Accessibility Survey

City of Downey Blodgett Avenue - Cheyenne Street To Adoree Street

Date of Inspection
4/7/2017

Disability Access Consultants

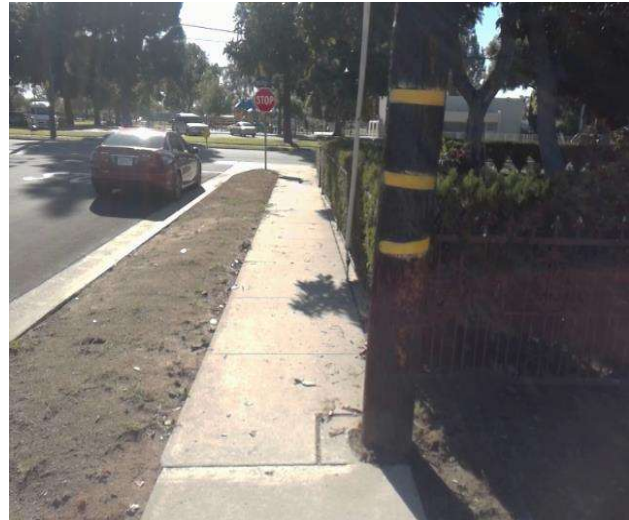
Sidewalk width at the obstruction is not compliant.

On-Site Finding 40.00 inches

Sidewalk width at the obstruction shall have the recommended value.
